ONSITE SEWAGE DISPOSAL SYSTEM

PROPERTY ADDRESS: 1020 Thunderbird Drive

SUBDIVISION: Fairlane Farms

LOT: 41

TRENCH/DRAINFIELD DATA

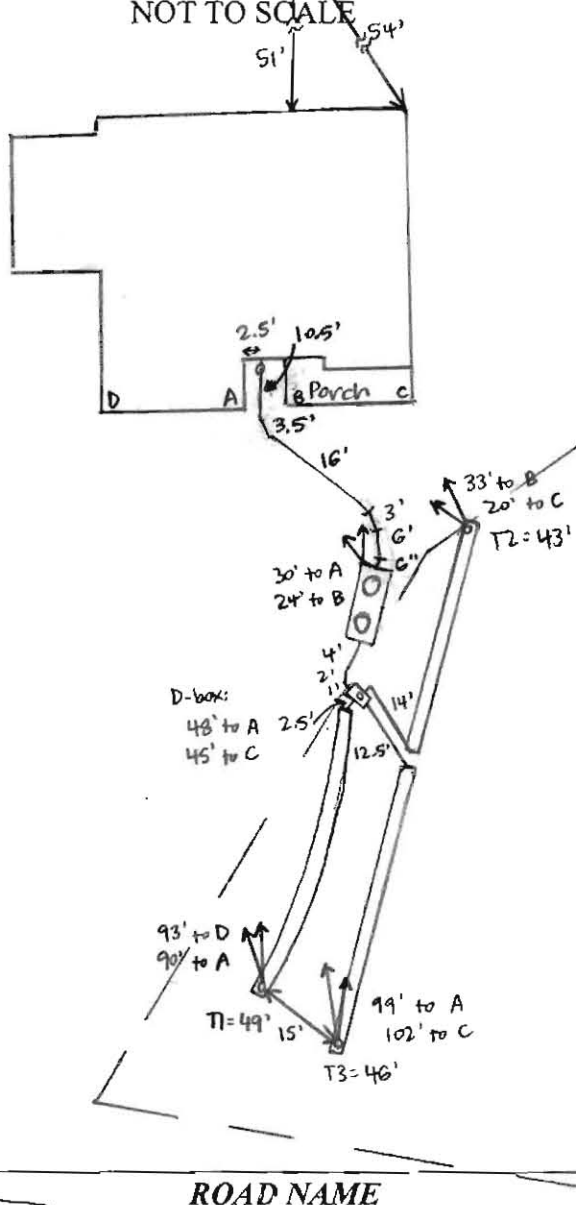
9/28/18 Met S. Carroll on site for layout. SDA corners + tank staked. Moved tank location farther from house to keep away from grading at porch and swale through front yard; builder OK with move. Sewer line comes out of house at the front. Fall is OK. (SC) [Spoke with Hank Oswald + Jeff Williams - trenches are close to 25% + slopes near road and should be moved off 25' +. OK to set tank, adjust trench spacing prior to install.] 10/2/18 Adjusted trenches, now 3' = 46' to keep 20' off SDA edge near road. OK for TI=49', T3=43' (SC)

INSTALLATION: 10/2/18 Tank set, S. Carroll digging line from house to tank. Pipe laid from house to tank, need house connection. (SC) 10/3/18 T2 installed + left open at ends for inspection. 3' wide, 3' to stone. (SC) 10/9/18 Trenches complete, T3 left open for inspection and TI left open at ends. 3' wide, 3' to stone. D-box installed + connected to tank and trenches. Levelled speed levelers in D-box. Need house connection. (SC) 10/10/18 House connection made - sewer line has a step down before 1st c/o. (SC)

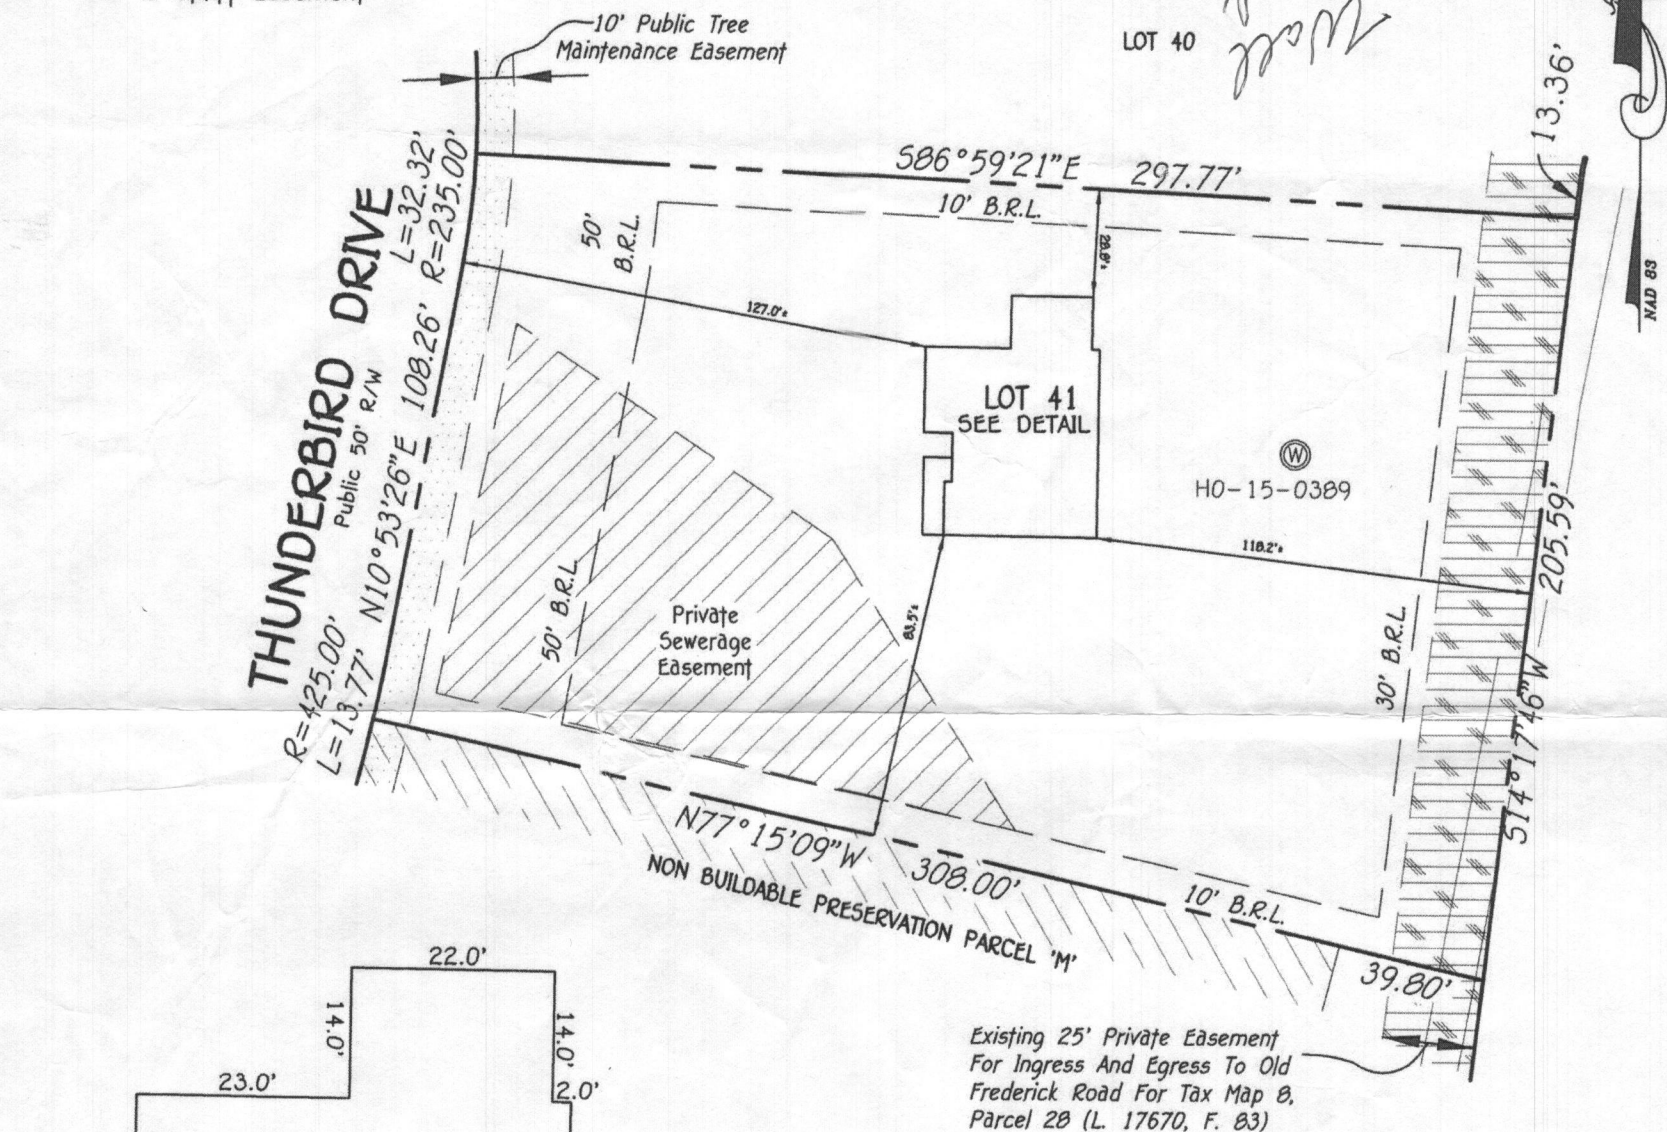
Sarah;
Keep 1st trench 10%
where it's shown
and shift 2nd trench
up toward tank.
Thanks,
Went
